City of Portland, Maine - Building or Use Permit Application

Proposed Project Description:
Add 4th Dormer; Per Plans

BUILDING PERMIT REPORT

REASON FOR PERMIT: Add 4th Dormer

3RD FLOOR DORMER

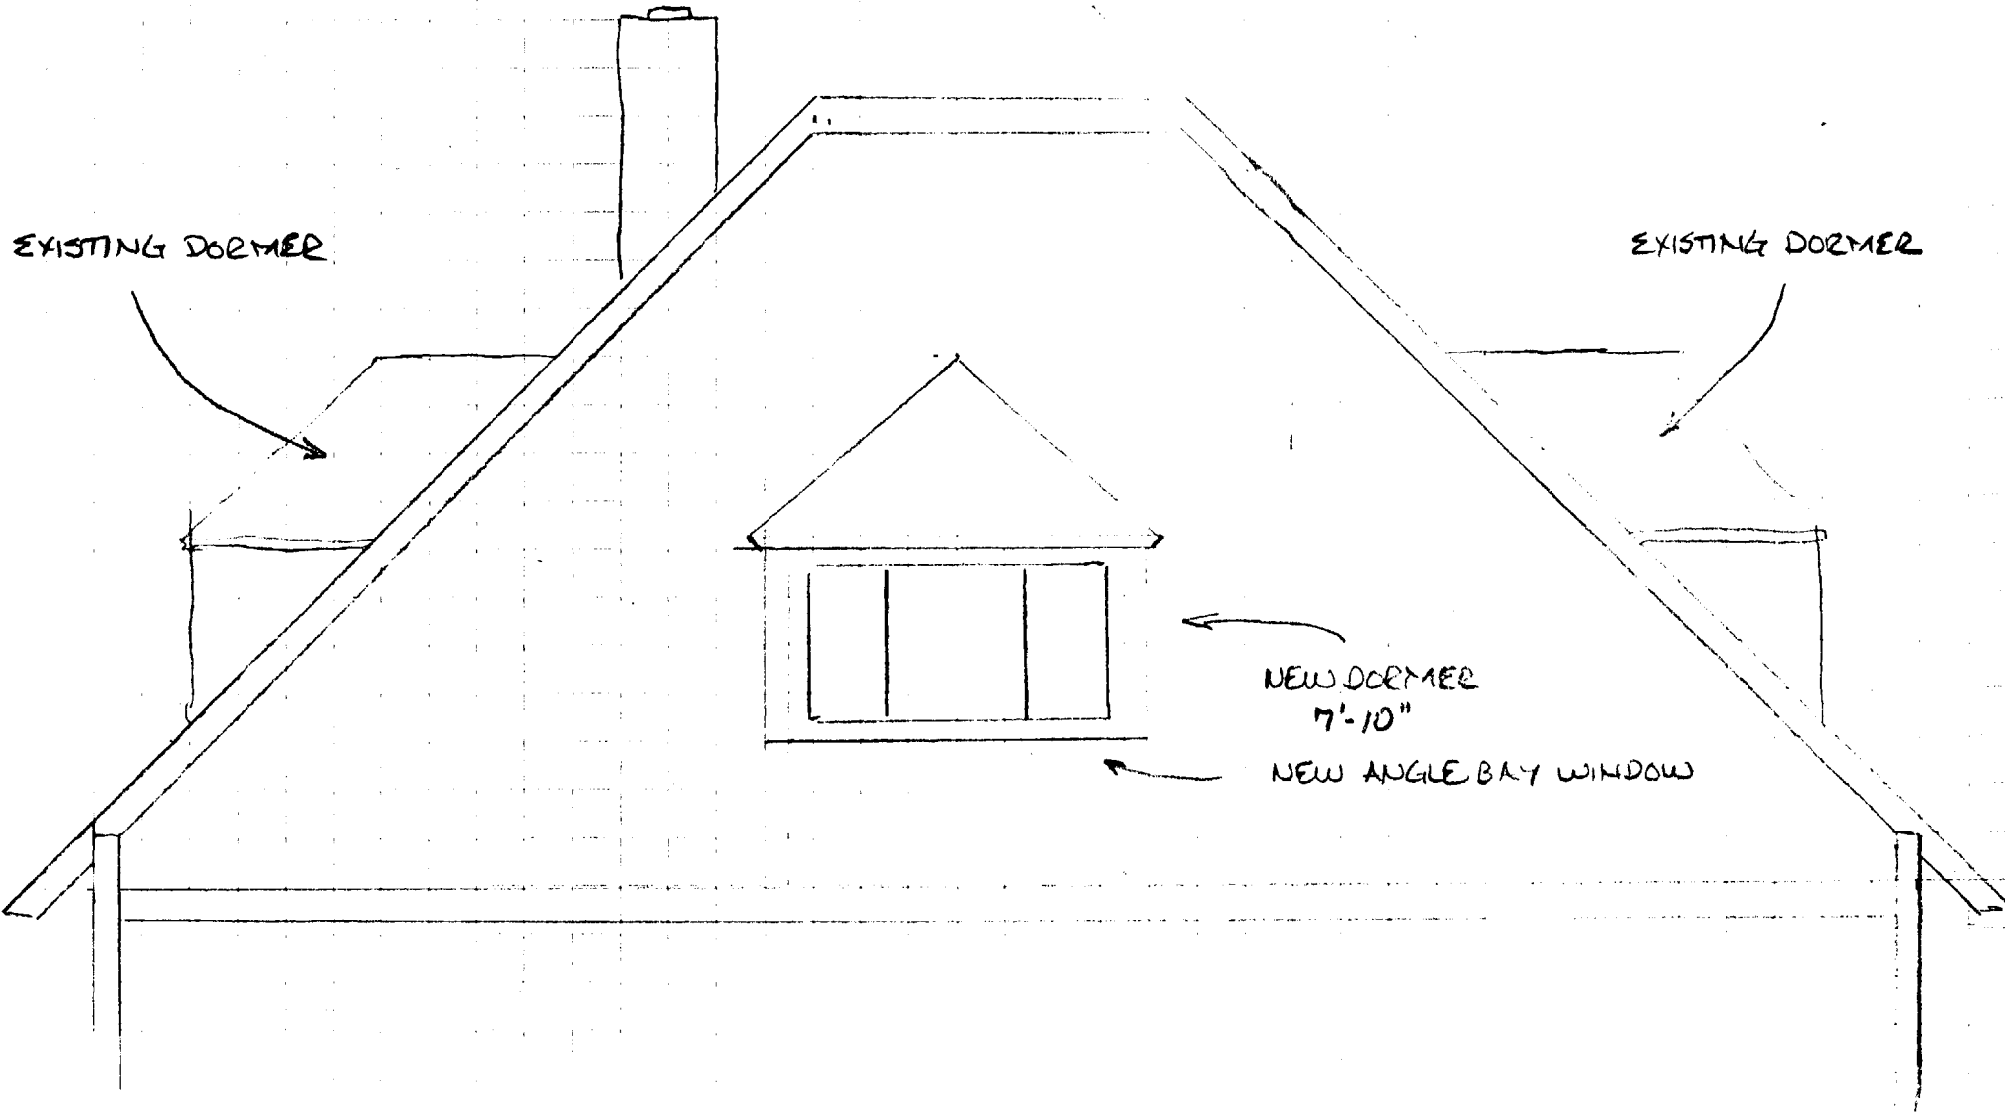
This permit is being issued with the understanding that the following conditions shall be met: *1, *16, *30, *33, *36, *32

29. All requirements must be met before a final Certificate of Occupancy is issued.
- X 30. All building elements shall meet the fastening schedule as per Table 2305.2 of the City's Building Code (The BOCA National Building Code/1996).

32. Please read and implement the attached Land Use Zoning report requirements. *Shall remain a single family - This is not an approval to increase the number of dwelling units.*

- X 33. Boring, cutting and notching shall be done in accordance with Sections 2305.3, 2305.3.1, 2305.4.4 and 2305.5.1 of the City's Building Code.
34. Bridging shall comply with Section 2305.16.

35. Glass and glazing shall meet the requirements of Chapter 24 of the building code. (Safety Glazing Section 2406.0)
- X 36. All flashing shall comply with Section 1406.3.10.
